PROPOSED CHANGE RTS 161 TO THE
DUANE ARNOLD ENERGY CENTER
TECHNICAL SPECIFICATION

The holders of license DPR-49 for the Duane Arnold Energy Center propose to amend Appendix A (Technical Specifications) to said license by deleting current pages and replacing them with attached, new pages.

FIGURE 3.6-1

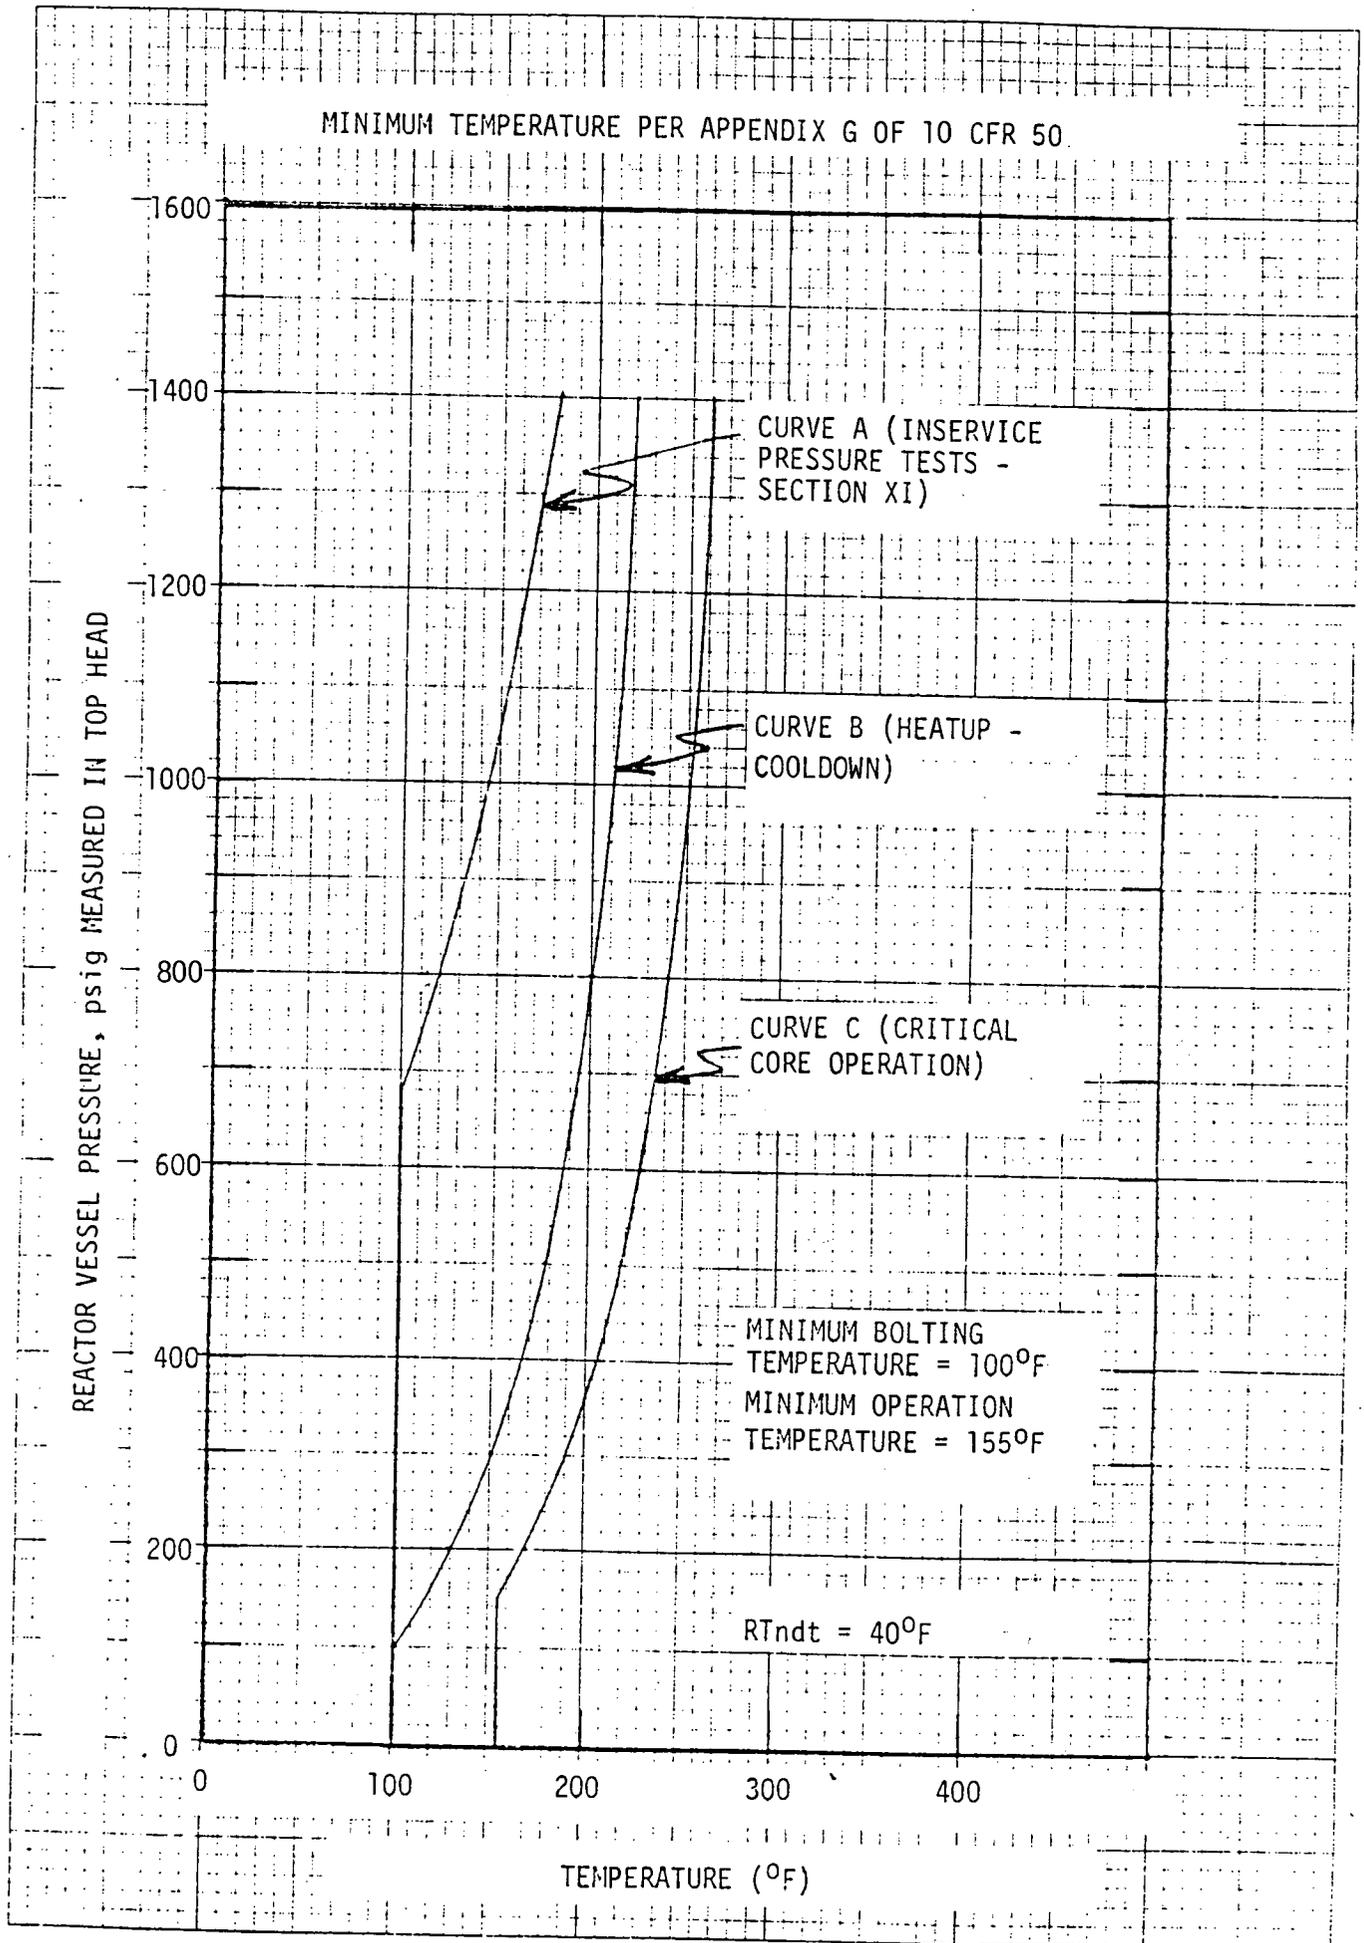
- (19) The paragraph on page 3.6-41 is moved to 3.6-40 and page 3.6-49 is changed to 3.6-41.
